TRANS/WP.29/GRE/2002/44
18 July 2002

PROPOSAL FOR DRAFT AMENDMENTS TO DRAFT REGULATION ON
ADAPTATIVE FRONT-LIGHTING SYSTEM (AFS)

Transmitted by the Expert from Poland

Figure 1: Idea of allocation of the "shoulder part".

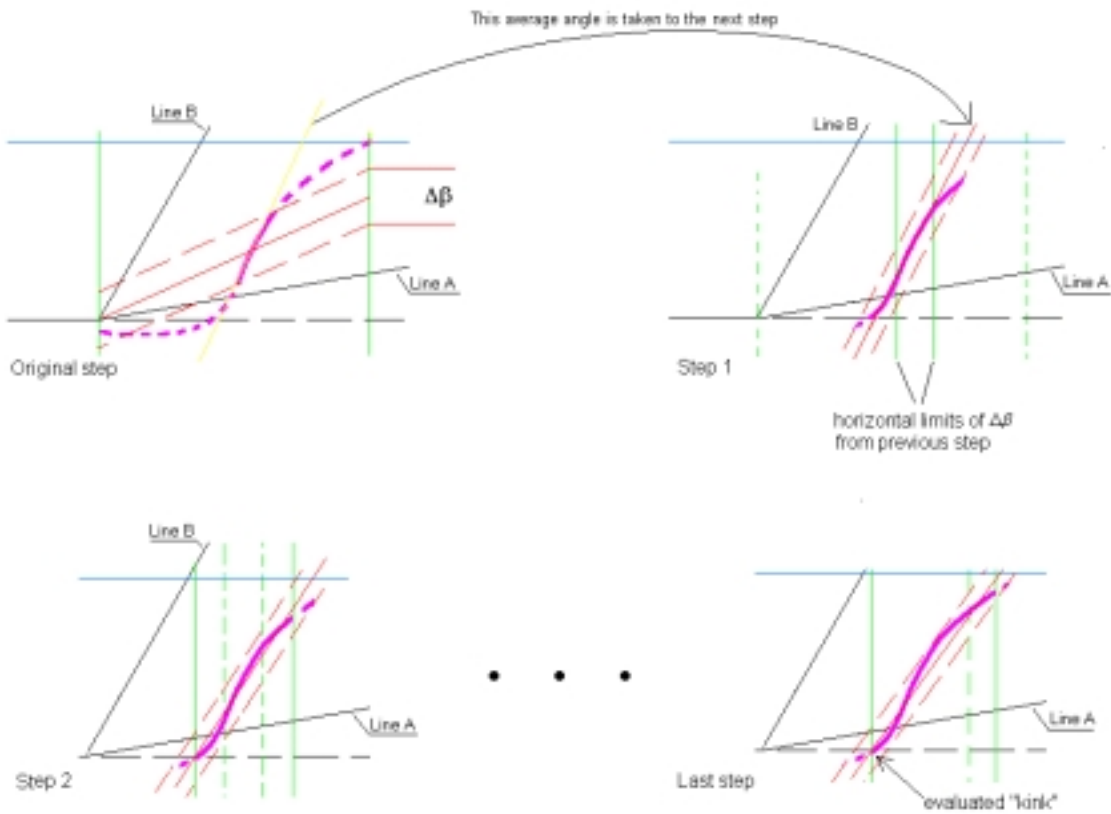
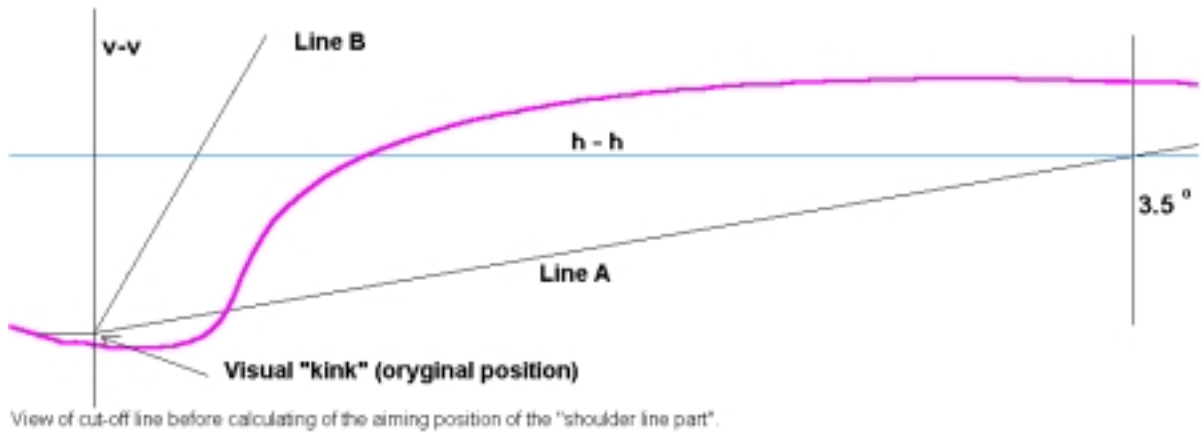
4.1.2. Horizontal adjustment:

Original "shoulder line part" co-ordinates (angle and kink point) of cut-off line is obtained by averaging of all co-ordinates of points in which $d^2(\log E) / d\beta^2 = 0$ scanned horizontally from v-v to 3.5 degree the right and vertically under h-h, with the step not bigger than 0.1 degree. This is original "shoulder line part" and their co-ordinates (angle and "kink point") are calculated. Then the points with co-ordinates lying in bandwidth of ± 0.2 degree from original "shoulder line part" under h-h are selected. In the next step selected co-ordinates are averaged as above giving next co-ordinates of "shoulder part" of "cut-off" line. Then selection and averaging is repeated until the next average co-ordinates of "shoulder part" do not differ from the preceding one.

An example of this procedure is shown on figure 1.
